Executive Director's Recommendation

PROJECT**Southern Expansion - Revised U.S. Air Force Memorial Entrance**

Arlington National Cemetery
Arlington, Virginia

Approval of final site and building plans

Alternative Entrance Design – no bollards

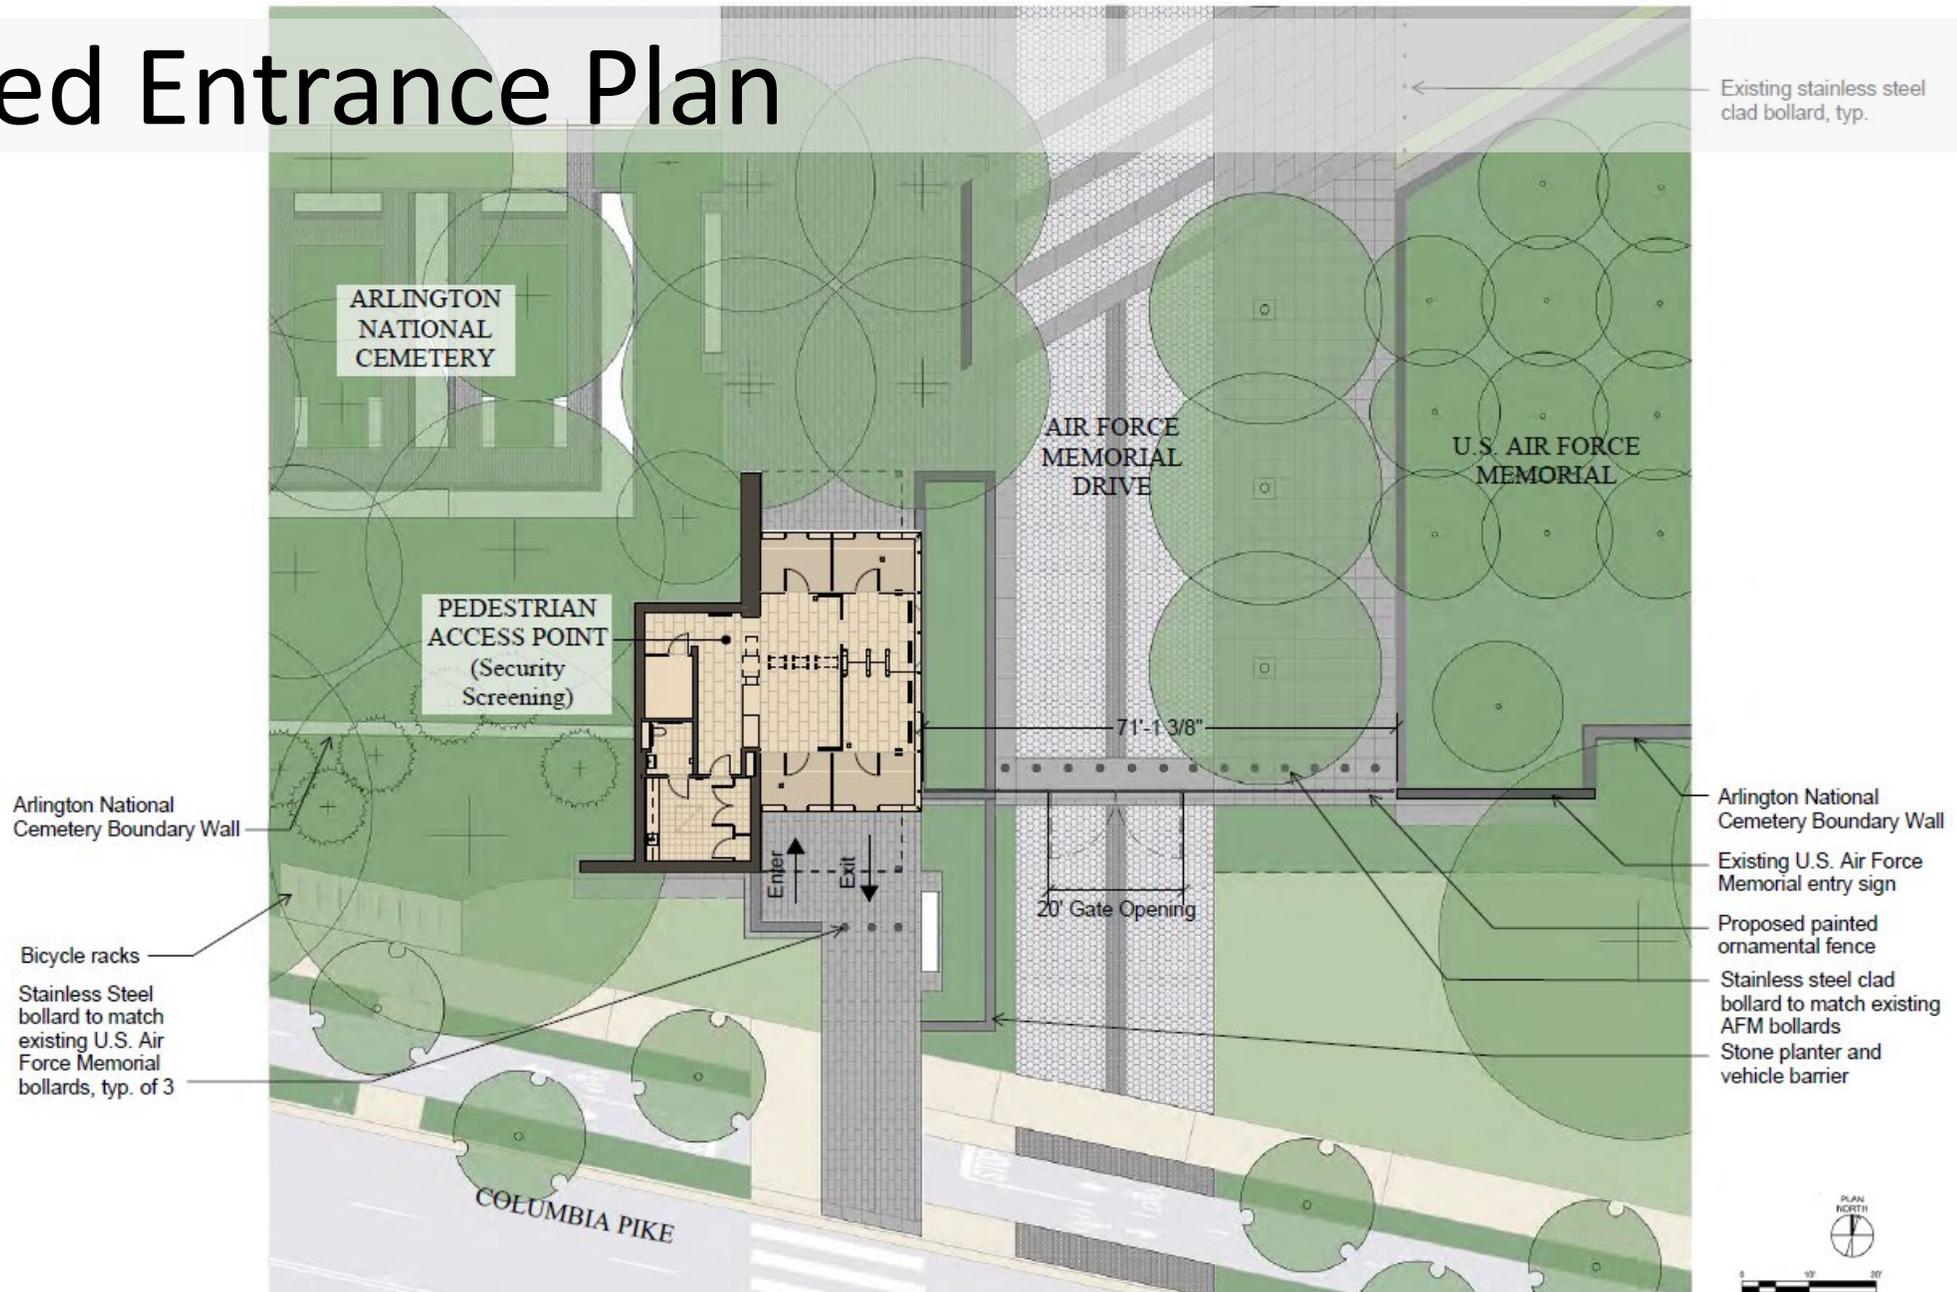
The USACE considered an alternative vehicular entrance gate design that removed the bollards in response to NCPC's review. Removing the bollards without fortifying the gate would have reduced the gate rating to less than a PU-30 (which is secure enough to prevent a pickup truck from driving through). The USACE then considered fortifying the gate to meet the PU-30 rating which required 8-inch-wide gate posts and additional diagonal cross members to anchor the system. Pickets were also added on the top of the fence. The posts would have been noticeably wider than the posts from

the original November 2020 design, which were 4-inch-wide posts. While NCPC and CFA staff generally prefer the removal of the bollards, the alternative gate design in this instance is not more welcoming than the original design and was found to be visually more intrusive on the overall design of the U.S. Air Force Memorial.

Following this joint meeting with NCPC and CFA staff, the applicant submitted a revised design which consists of retaining the bollards, installing a fence similar to the original design and additional landscaping on both sides of the new gate. Staff also notes this design includes three new stainless-steel bollards installed on the pathway leading to the front of the new pedestrian access control point and a low knee wall on the east side of the pathway to address vehicle safety concerns. The bollards and knee wall are intended to prevent an errant vehicle from injuring visitors waiting to enter into the cemetery at the new pedestrian access control point. Staff **finds the revised design best creates a welcoming entrance by minimizing the overall appearance of the gate, protects the visitor entrance area, and maintains the formality of the memorial and cemetery design.**
